SEWAGE DISPOSAL TESTING

July 11, 2017

Re: Beaufort Estates, Lot 3
 8441 Parreco Drive
 Revised Percolation Certification Plan

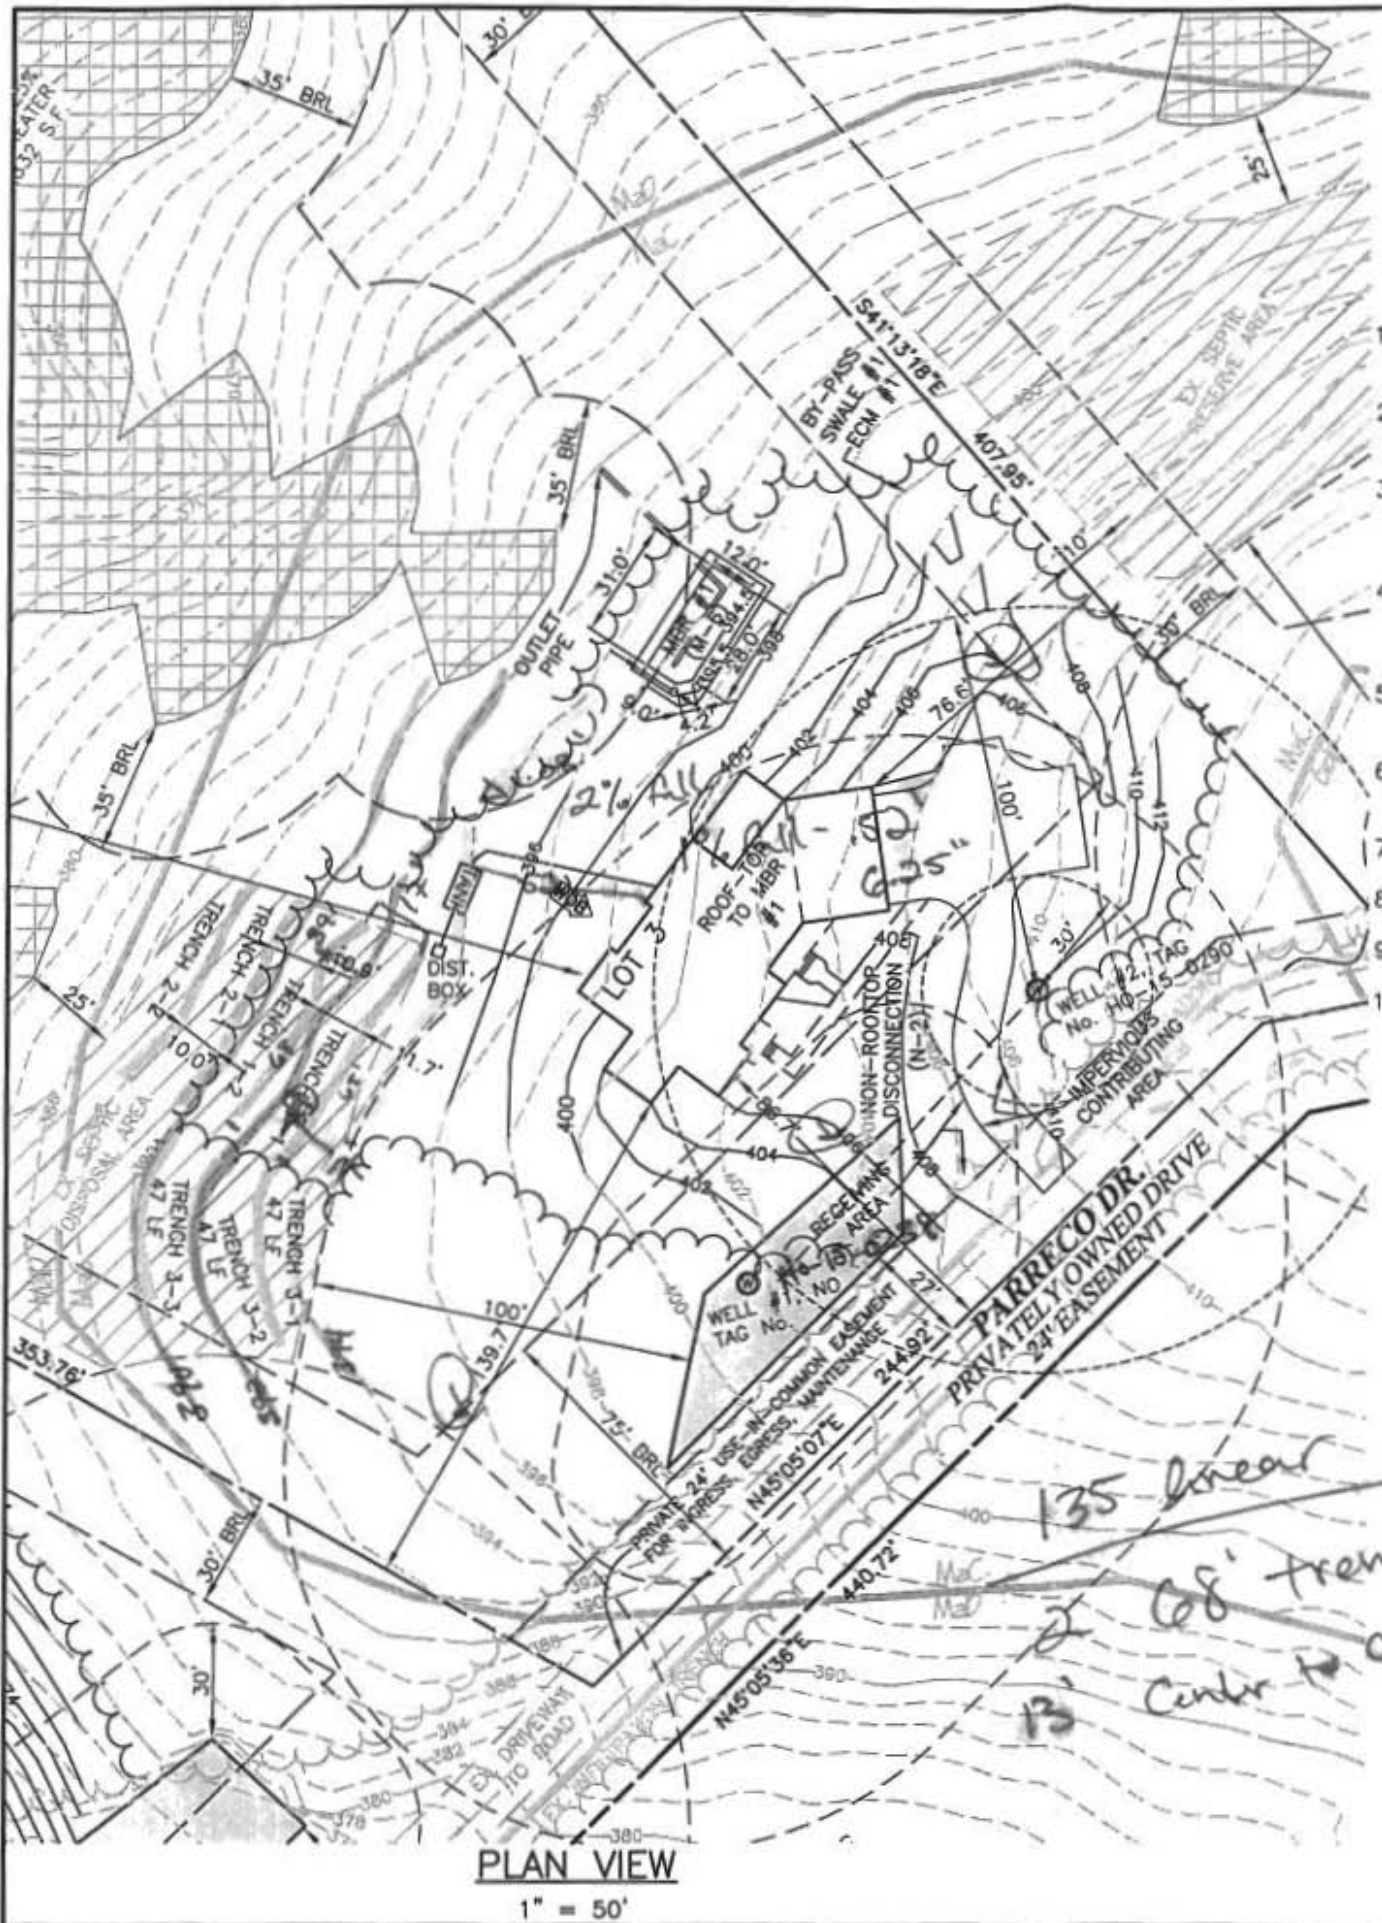
I am writing to in response to your comments dated July 5, 2017. The following is a point by point response to your comments:

- 1.) Both wells are now shown with Tag numbers.
- 2.) Note 6 has been changed to include both tag numbers.
- 3.) Note has been added stating both wells are to be tied together to serve the house.
- 4.) Third sewage disposal system is shown and calculations are provided.
